# Facility: Columbia Cosmopolitan Recreation Area

Address: 1615 Business Loop 70W      Date of Survey: 04/19/10 - 05/04/10

Photo 9

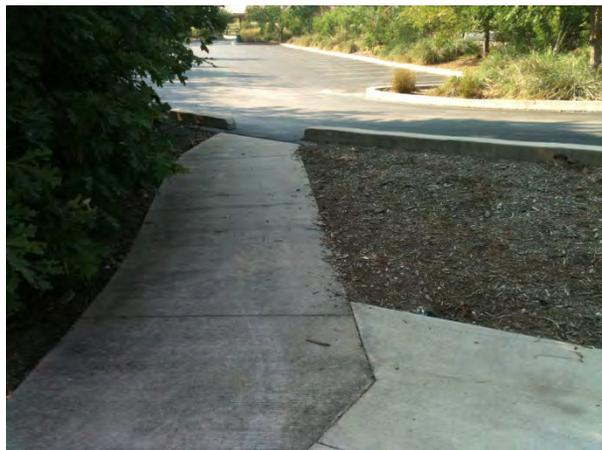
- Refer to site plan included with this report: (11) Patch/smooth/fill 1.5" gap between asphalt and concrete walk leading up to the Dexheimer Shelter (see photo 8 above). **Estimated Cost: \$100.00**
- Refer to site plan included with this report: (12) Replace section of walk (~29' long x 4' wide & ~26' long x 5' wide) leading from the parking area just NW of the Restroom Building over to the level concrete pad in front of the Restroom Building (see photos 9 & 10 below). Existing walk sections have cross-slopes up to 8%. Replacement concrete walk shall have a max. slope of 5% as much as is feasible and a max. cross-slope of 2%. **Estimated Cost: \$2,594.00**

Photo 21

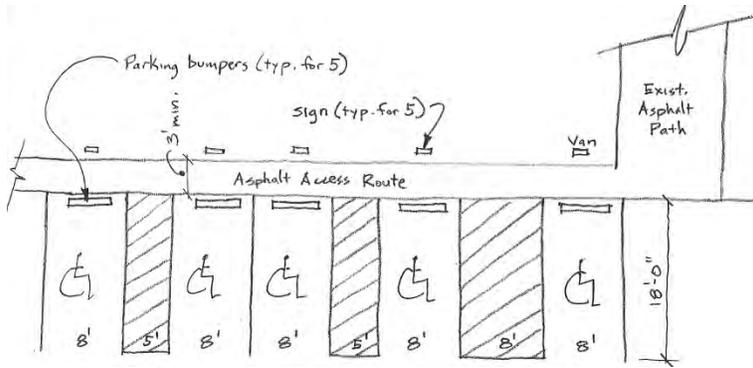
- Refer to site plan included with this report: (25) Replace a deteriorated section of sidewalk (~15' wide x 10' long) at access path leading from parking lot (27a. on parking map) to the clubhouse (see photo 21 below).
